Access Compliance Report

Public Rights-of-Way (Curb Ramps)

Intersection ID: 48464	Main Street: TARPWAY_RD	Cross Street: PETE_BROWN_RD	Location: SW
ADA ID: C4B78FF6C7E5	Ramp Type: Directional1	Initial Pass/Fail: Pass	Overall Compliance: No
		Severity Score: 2.5

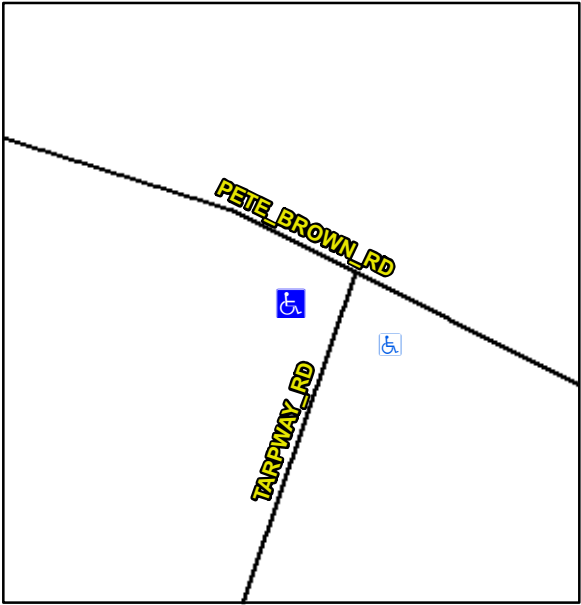
Codes/Mitigation Info/Possible Solution		Field Measurements/Component Compliance					
 Street 1 Name TARPWAY RD Stop Condition-Street 1 StopSign Street 2 Name N/A Stop Condition-Street 2 N/A	Possible Solutions:	Compliance	Description	Data	Compliance	Description	Data
	Remove & Replace Entire Ramp.	N/A	Ramp Length (in)	48.0	No	Grade Break?	No
		Yes	Ramp Width (in)	73.0	N/A	Grade Break Slope (%)	N/A
		Yes	Ramp Slope (%)	6.2	N/A	Grade Break XSlope (%)	N/A
		Yes	Ramp XSlope (%)	1.9			
		Yes	Flare Type LT	N/A	Yes	Flare Type RT	N/A
		N/A	Flare Slope LT (%)	N/A	N/A	Flare Slope RT (%)	N/A
		N/A	Flare Traversable LT?	No	N/A	Flare Traversable RT?	No
		Yes	Landing Length (in)	71.0	Yes	DWS Provided?	Yes
		Yes	Landing Width (in)	71.0	Yes	DWS Contrast?	Yes
Surveyor Notes: N/A PROW/ADA: R304.5.2, R305.1.4, R305.2		Yes	Landing Slope (%)	1.2	Yes	DWS Length (in)	24.0
		Yes	Landing X Slope (%)	0.8	No	DWS Full Width?	No
		N/A	Landing Curb? (Y/N)	N/A	Yes	DWS Offset LT (in)	34.5

N/A	Shared Landing?	No	No	DWS Offset RT (in)	5.5
		Yes	Gutter Ponding?	No	Yes	Gutter Slope (%)	0.1
		Yes	Gutter Lip Ht (in)	0.0	Yes	Gutter X Slope (%)	1.9
		N/A	Painted X Walk1?	No		Road Slope (%)	1.3
			X Walk 1 Direction	To E		Road X Slope (%)	3.7
			X Walk 1 Width (in)	N/A		Clear Space?	Yes
			X Walk 1 Slope (%)	1.3	N/A	Clear Space to XWalk (in)	N/A
Total Cost: \$ 1600.00			X Walk 1 X Slope (%)	3.7	Yes	Storm Grate/Utility Hazard?	No
		N/A	Ramp inside XWalk1?	N/A		Storm Grate/Utility Type	
		Yes	Any Obstructions?	No			N/A
			Obstruction Type		Yes	Surface Condition? (G/P)	Good
					N/A	Curb Slope (%)	N/A
